PROJECT: Town of Wedowee
CWSRF Project No. CS010883-02 & CS010883-04
ARC Project No. AL-20358-2021
KG Project #20-0016

ADDENDUM NO. Two (2)

DATE: September 15, 2023

PLANS OF THE SEWER SYSTEM IMPROVEMENTS FOR THE TOWN OF WEDOWEE RANDOLPH COUNTY, ALABAMA

06 PUMP HOIST FOOTING DETAIL
 SCALE: N.T.S.

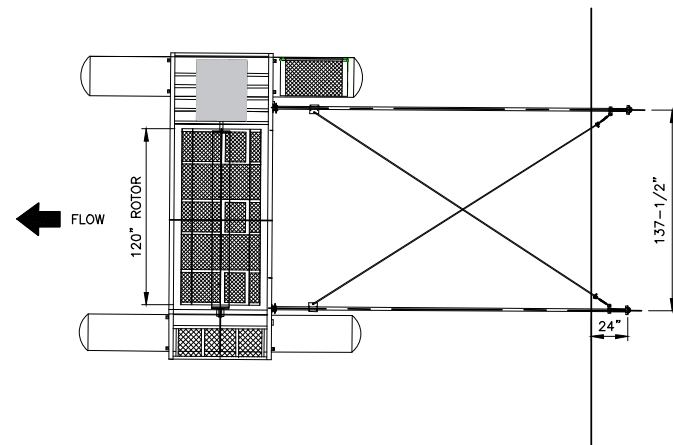
4. The intent of the contract plans is for two pump hoist bases – one at influent pump station and one at effluent pump station – and one pump hoist to be furnished by the SUPPLIER. Pump hoist bases at both locations shall be installed per the detail on contract plan Sheet C15. The pump hoists shall be considered incidental to Bid Item No. 2 and Bid Item No. 7. Pump hoist shall provided by the specifications as follows:

- A. Crane - (1) Thern First Mate 500, 5PF5 Series Portable Davit Crane
 - B. Winch – (1) Thern 4WM2-K Worm Gear Hand Winch, Drill Drivable
 - C. Base – (2) Thern 5BP5 Pedestal Base

- D. Crane and base to be finish powder coated
 - E. Wire Rope shall be 7x19 galvanized aircraft cable with swivel hook and latch.
